**ADDENDUM # 2**

Contract No. DN01089  
TIP No.: N/A  
Federal Aid No.: Helene  
WBS Element: DF18314.2088026; DF18314.2088027; DF18314.2088064;  
DF18314.2088065; DF18314.2088081  
County: Transylvania  
Description: Emergency Repair: Grade, Pave, Drainage, Slope Stabilization,  
Guardrail, Erosion Control, Traffic Control, at Various Locations  
Along SR 1533 (Everett Rd), SR 1534 (Hart Rd), SR 1536 (Cascade  
Lake Rd)  
Letting Date: January 28, 2025

**Content Summary: Pre-Bid Meeting Minutes and Sign in Sheet, Addition of  
Moratorium provision, Revise Roadway plan sheet, Bidder  
Questions/Concerns, Associated Department Responses**

**HURRICANE HELENE EMERGENCY REPAIRS  
 SOIL NAIL RETAINING WALL WITH SHOTCRETE FACING**

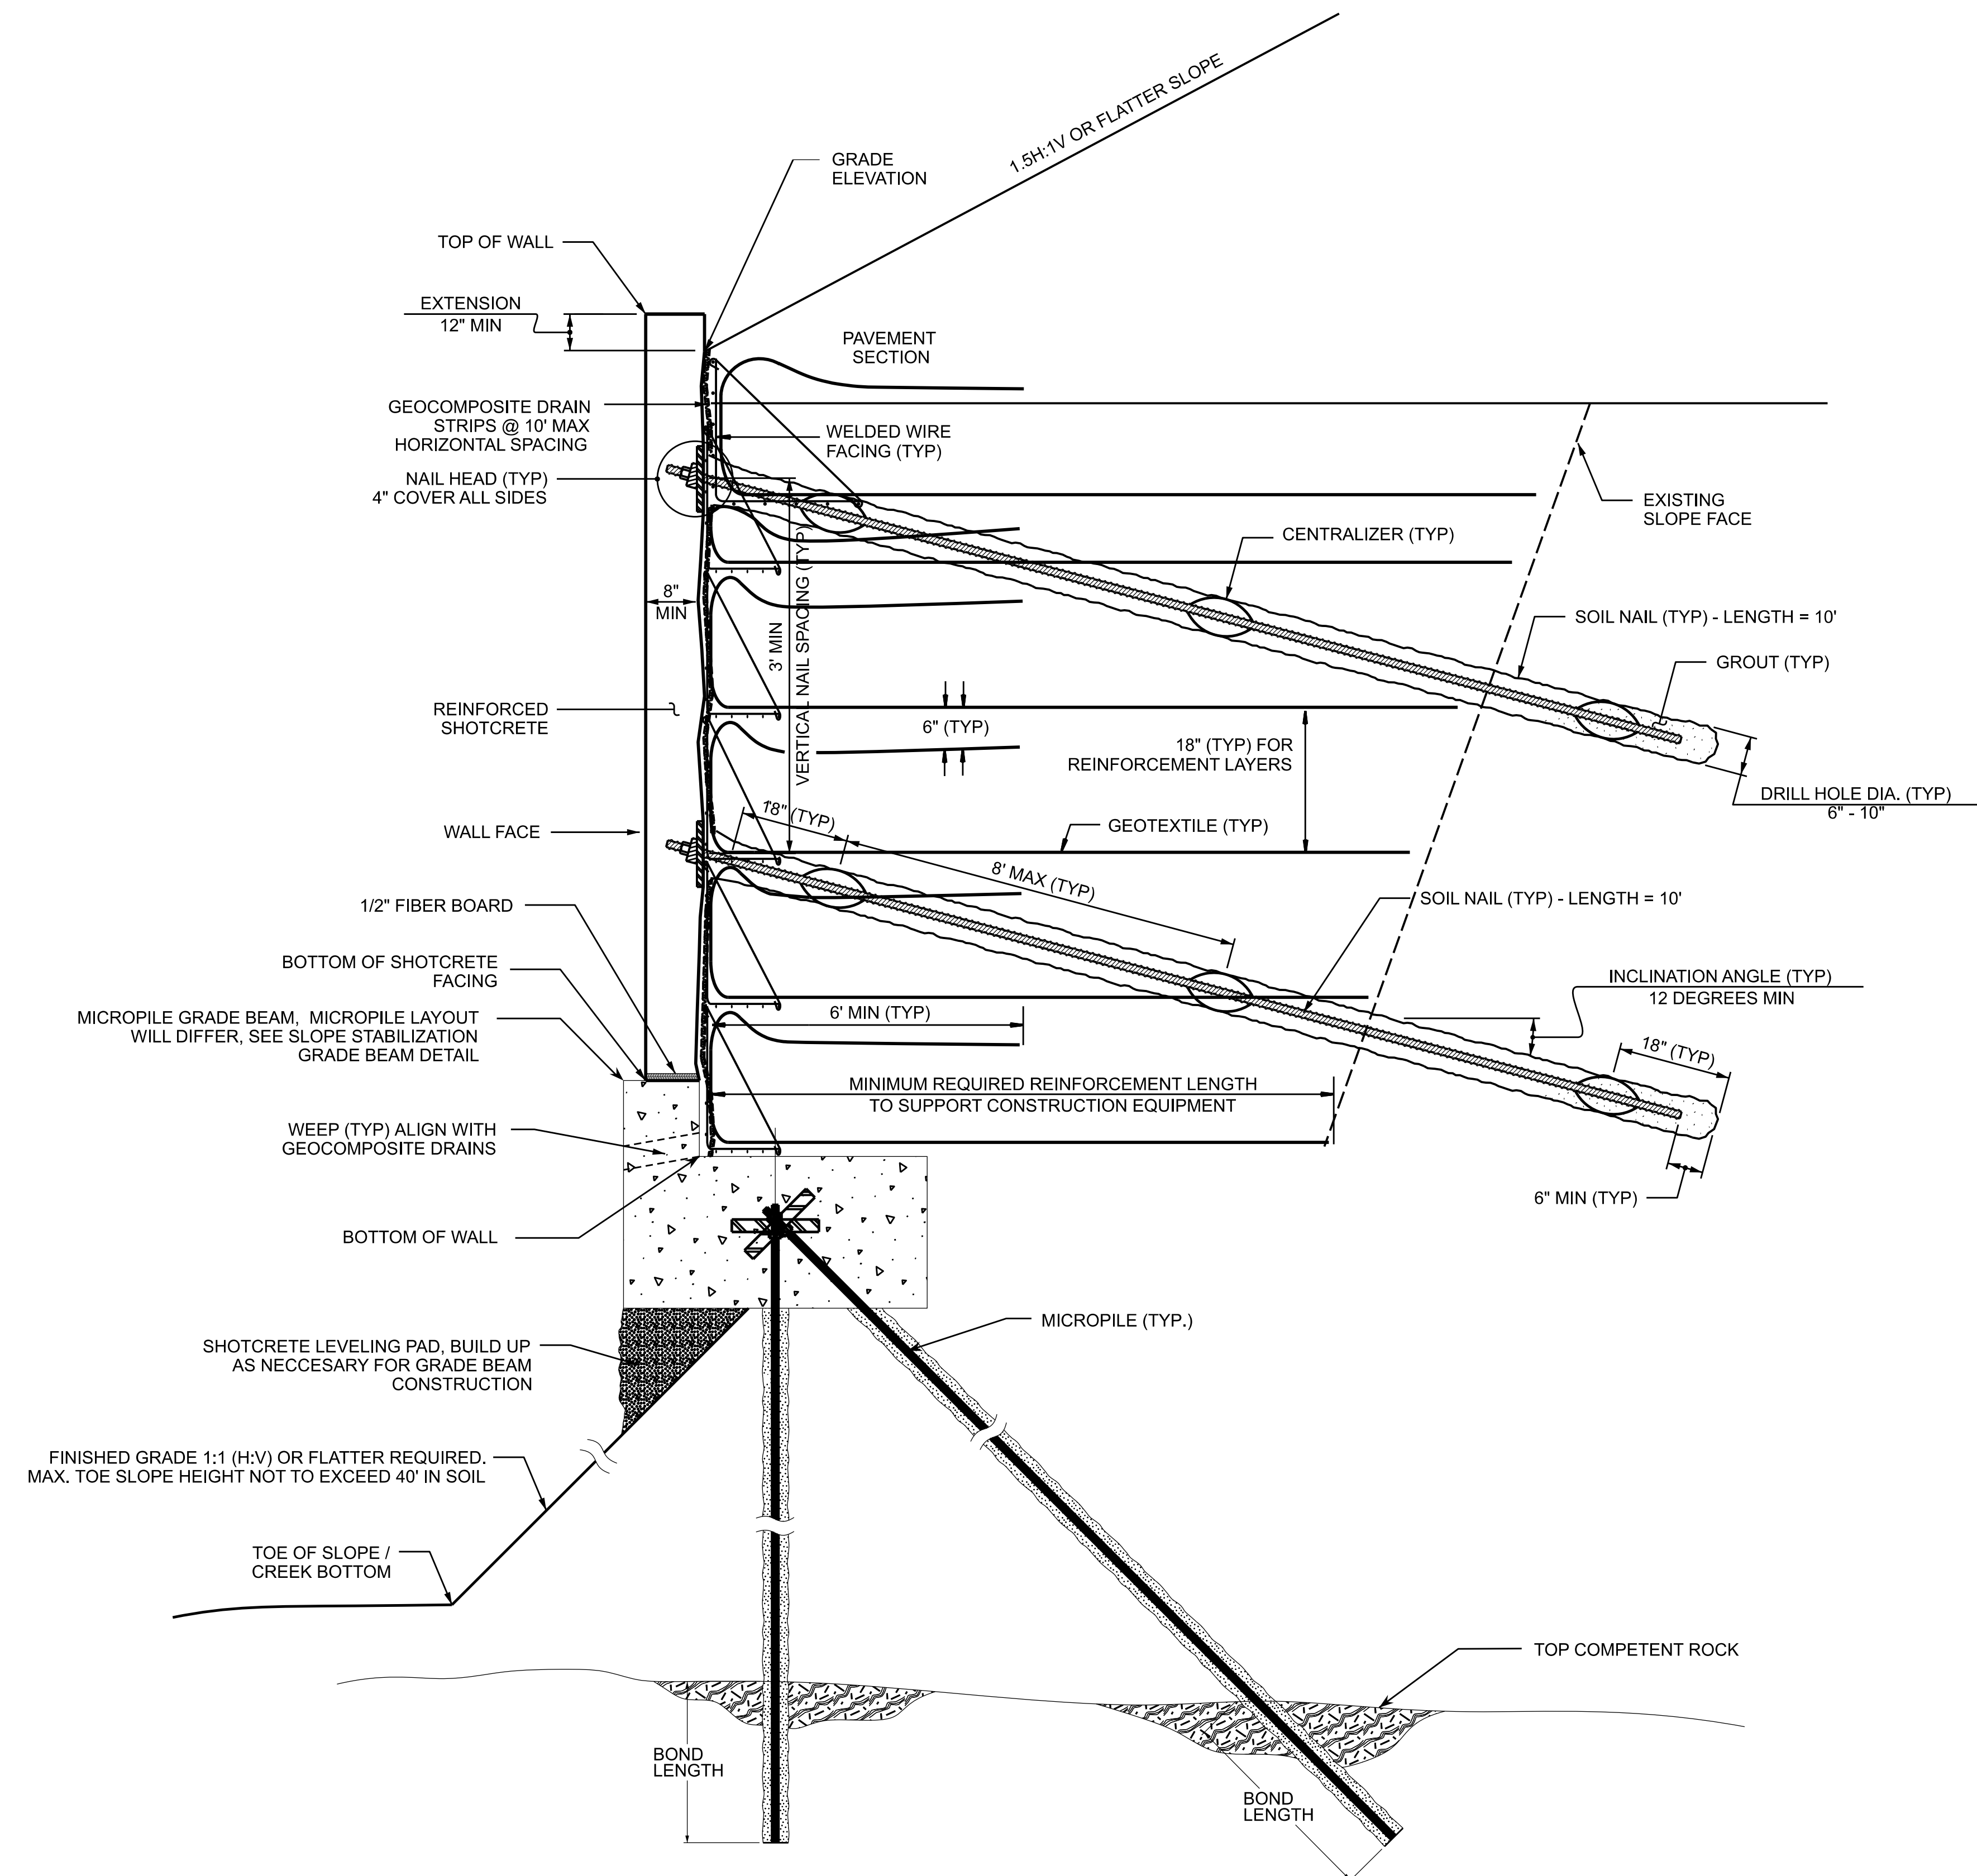
1. Pre-Bid Meeting Minutes
2. Pre-Bid Sign in Sheet
3. Addition of Provision **SP1 G18C CONSTRUCTION MORATORIUM on  
page G-6 of the Proposal**
4. Revise Roadway plan sheet 4 (of the pdf) labeled **Soil Nail Retaining Wall With  
Shotcrete Facing** with the attached.

- NOTES:**
- FOR SOIL NAIL WALL, SEE SOIL NAIL WALL PROVISION.
  - FOR MICROPILE GRADE BEAM, SEE SLOPE STABILIZATION GRADE BEAM PLANS AND MICROPILE PROVISION.
  - FOR MICROPILES, SEE MICROPILE PROVISION.
  - ESTIMATED SOIL NAIL AVERAGE LENGTH = 20'
  - ESTIMATED MICROPILE AVERAGE LENGTH = 15'
  - MINIMUM MICROPILE ROCK BOND LENGTH = 5'
  - MINIMUM SOIL NAIL ROCK BOND LENGTH = 5'
  - MINIMUM OVERALL SOIL NAIL AND MICROPILE LENGTH = 10'
